## **APPENDIX A: BROADWATER CORRESPONDENCE**

**Re: Letter of Intent  
Broadwater Energy Liquefied Natural Gas Terminal and Related Facilities  
Long Island Sound, New York**

## Response to US Coast Guard Request of October 5, 2005

**Response of Broadwater Energy to US Coast Guard's  
December 19, 2005 Request for Information**

Figure 4-1 LNG Head above Water Leak

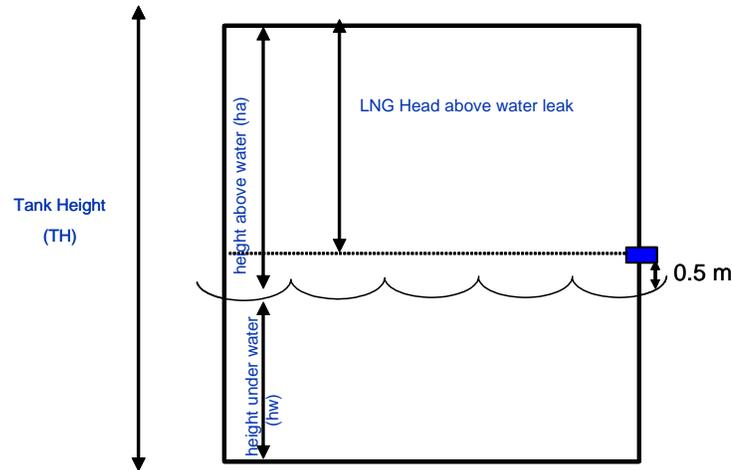
DNV has been requested to provide a qualitative comparison of the thickness and material strength of the outer and inner hull plating as well as the horizontal distance between the outer and inner hulls that was used for the Sandia Report versus the future generation of LNG carriers and FSRU. The future generation of LNG carriers to consider will have a capacity of up to approximately 250,000 m<sup>3</sup> and the FSRU will have a capacity of 350,000 m<sup>3</sup>. This will form the basis to evaluate whether the breach sizes that were determined as part of the Sandia Report can be applied to the FSRU and the future generation of LNG carriers.

The DNV consequence modeling is based on site specific information while the Sandia study is based on generic data. The release rate is largely dependent on the amount of LNG head above the breach. A breach in both the FSRU and LNG carrier has been assumed to occur just above the water line. This assumption results in the largest LNG head and release volume and consequently the most conservative results. A simplification of the LNG head in a tank is illustrated in Figure 4-1.

The Broadwater project is currently considering an FSRU with eight tanks that each hold a volume of approximately 45,000 m<sup>3</sup> of LNG. The LNG carriers that unload at the Broadwater facility may vary in size. This study attempted to be conservative in its assumptions; therefore, one of the largest sized carriers was chosen as a base case (250,000 m<sup>3</sup> carrier with six storage tanks). The tank volumes, release volumes and LNG head that have been used as the basis for the Broadwater site specific evaluations are presented in Table 4-1, together with the data use in the Sandia Report.
